# Magnus VLF

## Unload Table Panel Upgrade

**Document Number**
**719-00773A-A**

06 Dec 2006

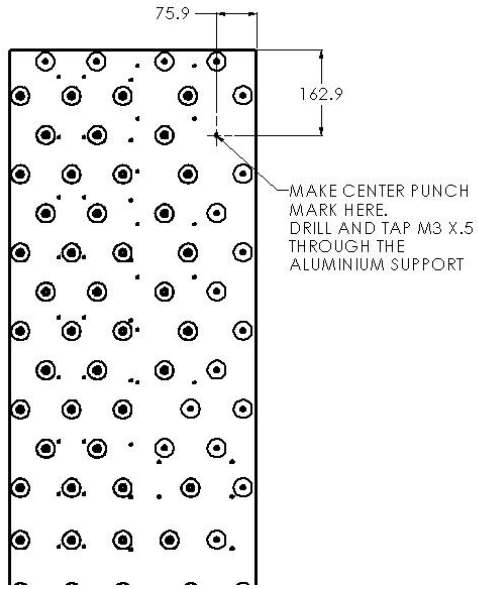
The new recessed plastic plate supports improve the unloading of certain size plates. This is done by eliminating the corner where the plates got stuck. The elimination of that corner also improves plate shuffle and increases the plate eject reliability.

**Note:** If you are upgrading the center panel, the device will not longer have the plate rotator upgrade capability.

- Complete upgrade kit – 512-00402A
- Side panels only upgrade kit – 512-00403A
